VIRGINIA ELECTRIC AND POWER COMPANY
RICHMOND, VIRGINIA 23261

VIRGINIA ELECTRIC AND POWER COMPANY
SURRY POWER STATION UNITS 1 & 2
ADDITIONAL INFORMATION CONCERNING NUREG-0737, ITEMS
II.F.1.4 CONTAINMENT PRESSURE MONITOR;
II.F.1.5 CONTAINMENT WATER LEVEL MONITOR;
II.F.1.6 CONTAINMENT HYDROGEN MONITOR

In response to your letter of January 11, 1983 requesting additional information concerning Items II.F.1.4, II.F.1.5 and II.F.1.6 of NUREG-0737, please find attached Vepco's submittal detailing the accuracies and time responses of our containment post-accident monitoring equipment, as well as the placement of our hydrogen monitor intake ports at Surry Power Station.

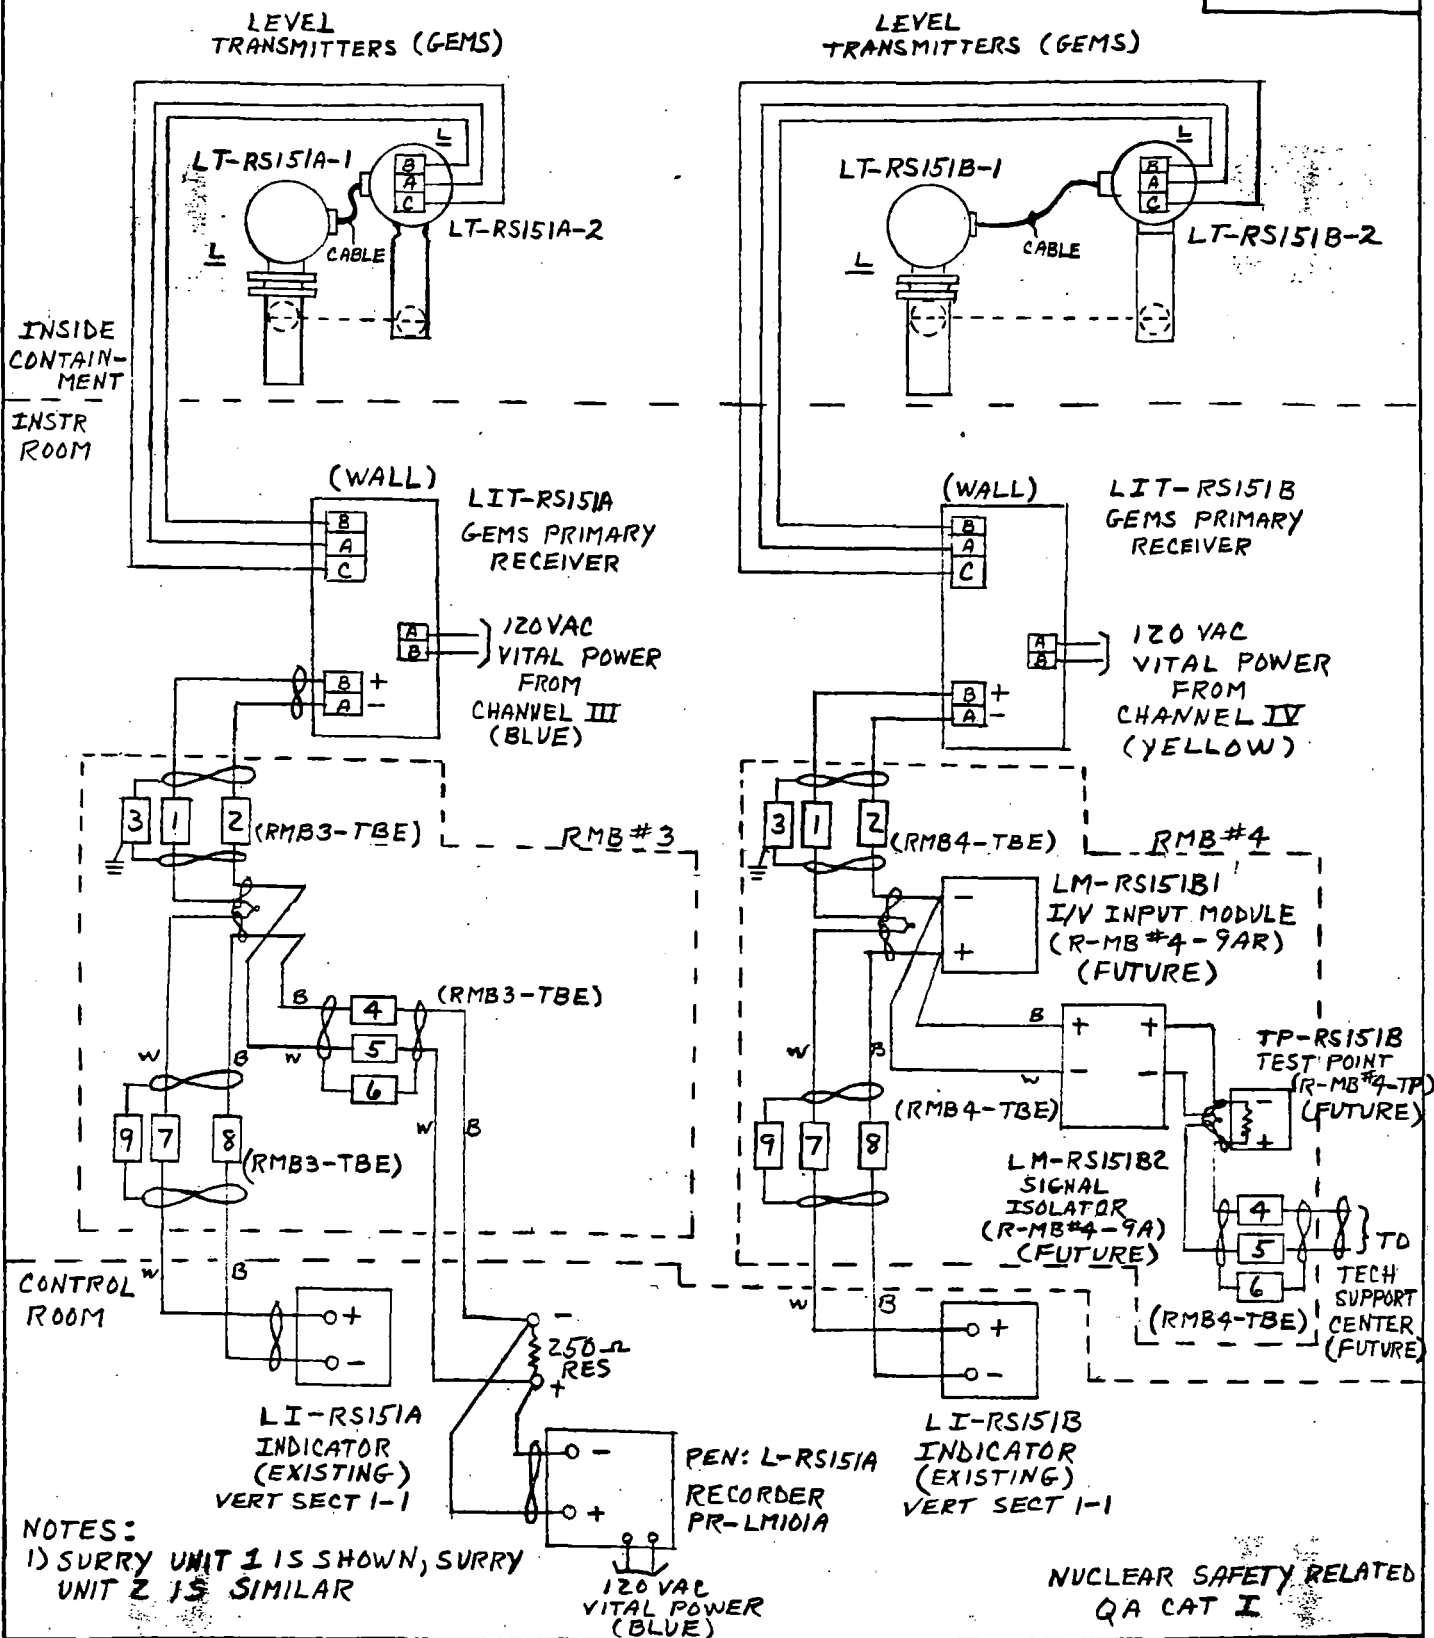
Q.4. (II.F.1.5) What is the accuracy of your water level monitor? State this for both the wide range and narrow range instruments.

Narrow Range

Transmitter (% of scale):	$\pm 2.3\%$
System power supply:	$\pm .5\%$
Indicator (% of scale):	$\pm 1.5\%$
Total:	$\pm 4.3\%$

Wide Range:	$\pm 1.65\%$
Narrow Range:	$\pm 2.79\%$

Draft 2 NUREG 0660 dated January 23, 1980 stated that narrow and wide range containment water level instruments shall have a measurement accuracy of $\pm 5.0\%$. This requirement is met with present instrumentation.

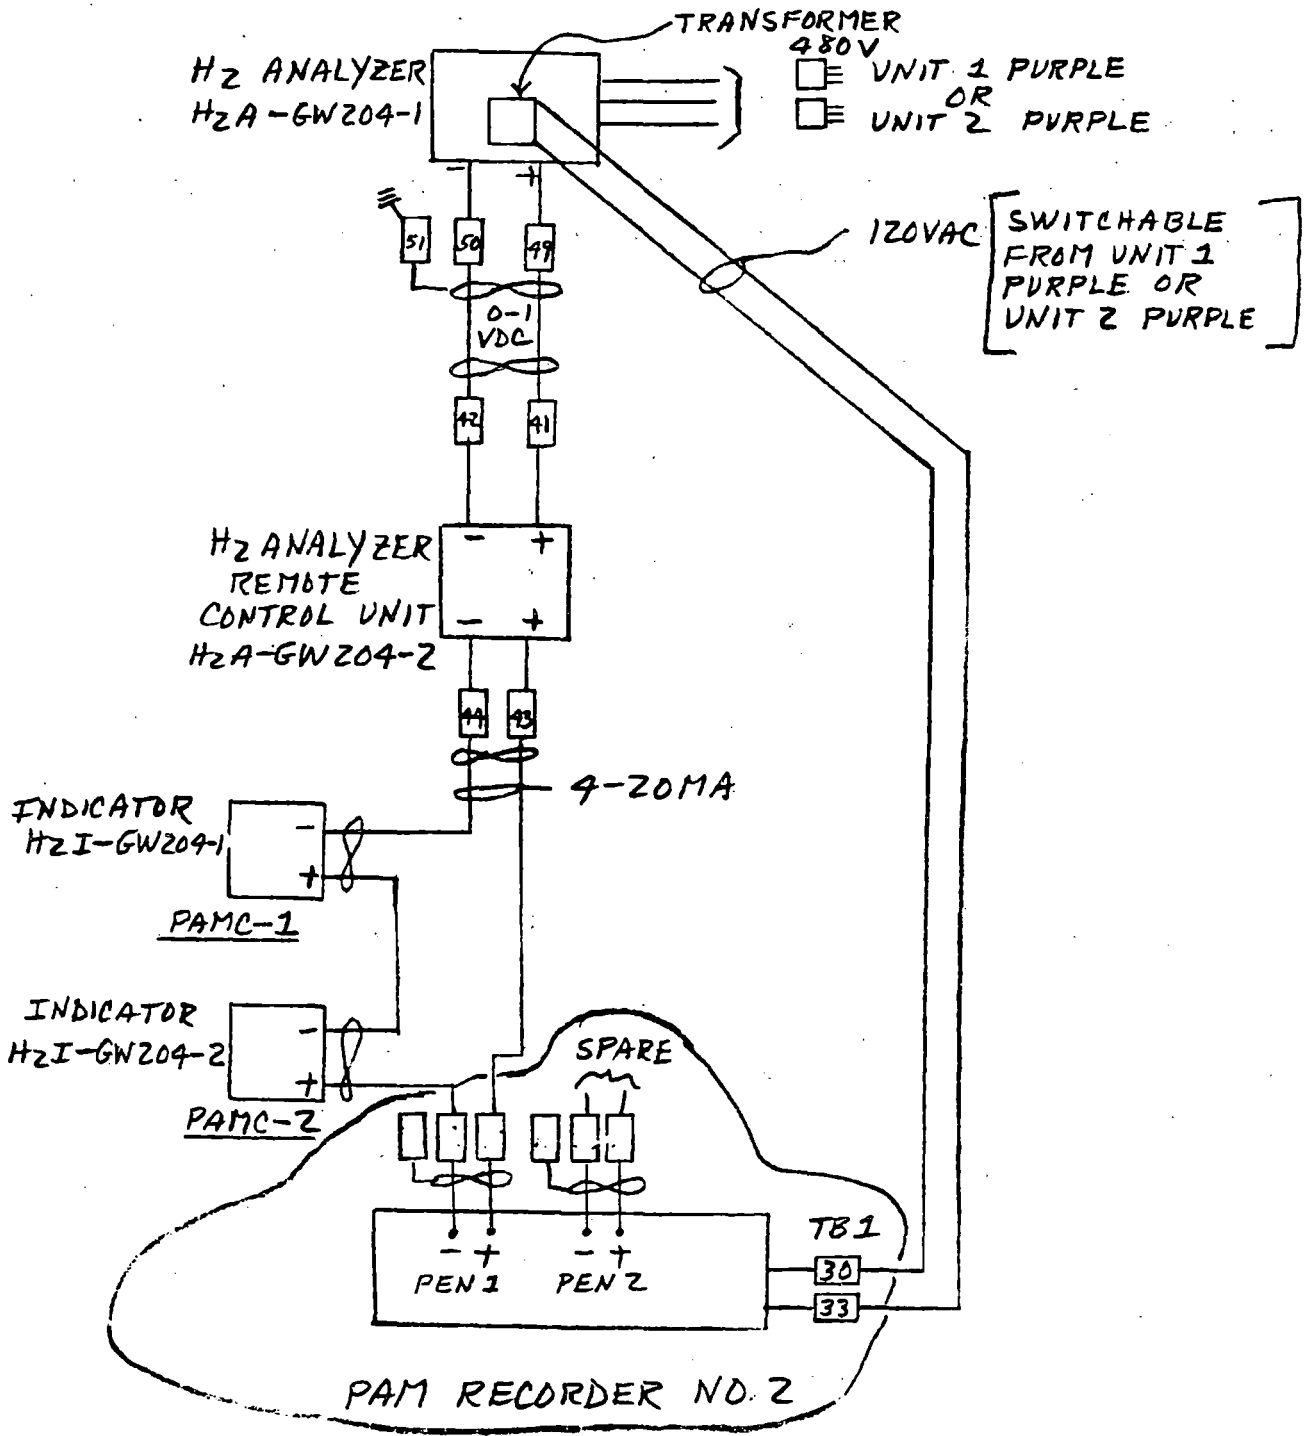
Q.2A. Provide a diagram of the configuration of modules that make up your PMS.

Q.2B. What is the accuracy of your pressure monitor?

Q.2D. What is the time response of your pressure monitor?

A. Drawings are attached providing the configuration of components that make up the PMS.

A. Indicating Loop

Transmitter (% of scale)	+ 0.25%
Indicator (% of scale)	+ 1.5 %

Recording Loop

Transmitter (% of scale)	+ .25%
Recorder (% of scale)	+ 0.5 %

Indicating Loop:	+ 1.6%
Recording Loop:	+ .7%

A. Indicating Loop

Transmitter:	0.1 second for 0%-100% of span
Indicator:	2.5 seconds for 0%-100% response

Recording Loop

Transmitter:	0.1 second for 0%-100% span
Recorder:	1.0 second for 100% step change

The response of the indicating loop as a worst case is essentially equal to the sum of the response of the indicator and the transmitter, the same logic holds true for the recording loop, in that the response of the recorder summed with the transmitter response is the response of the loop. Time responses are inherent to equipment based on vendor supplied information.
